SERVICE
2558D TELEPHONE SETS

1.01 Reissued to:

◆ Fig. 1—2558D Telephone Set Connections (Factory Wired) ◆

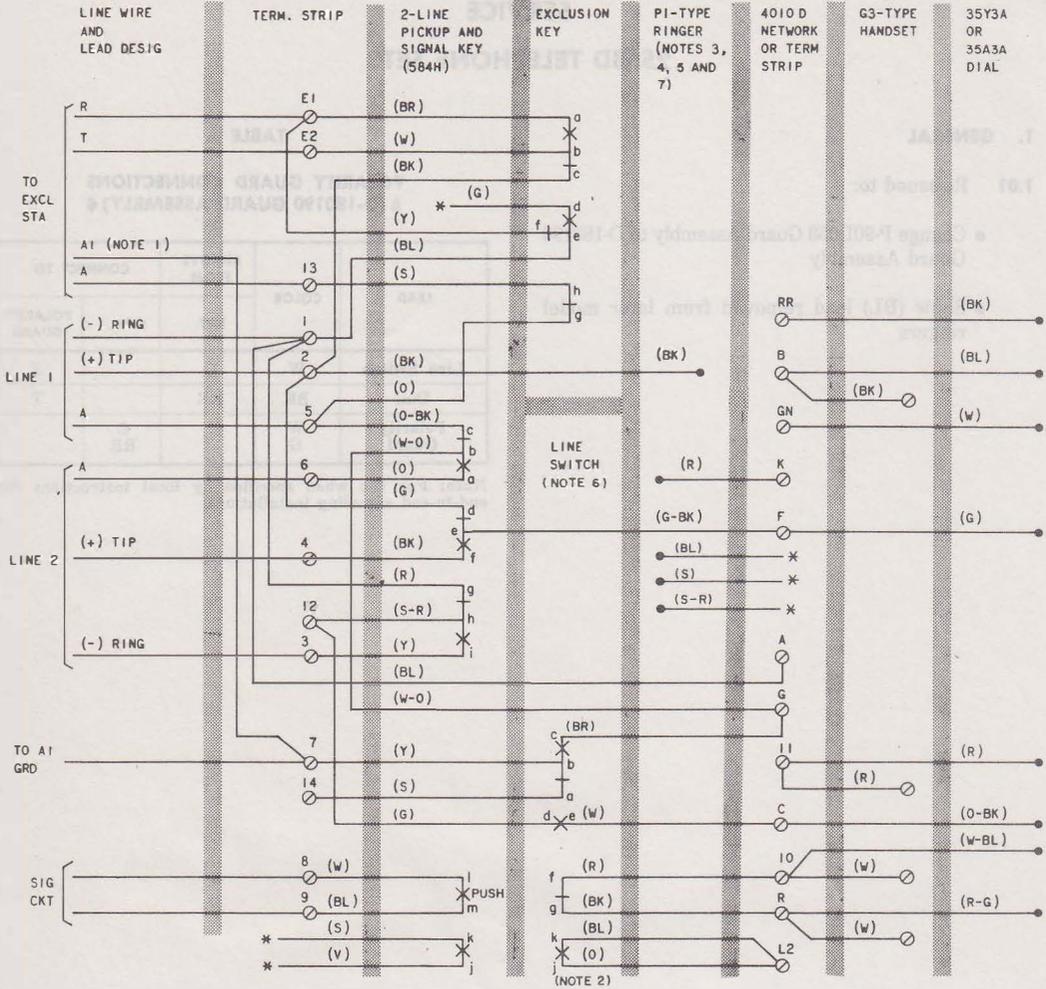
- Change P-90D053 Guard Assembly to D-180190 Guard Assembly
- Show (BL) lead removed from later model ringers

- bc-MAKES ab-BREAKS
 - de-MAKES fg-MAKES
7. (BL) LEAD HAS BEEN REMOVED FROM LATER MODEL RINGERS.
* INSULATED AND STORED
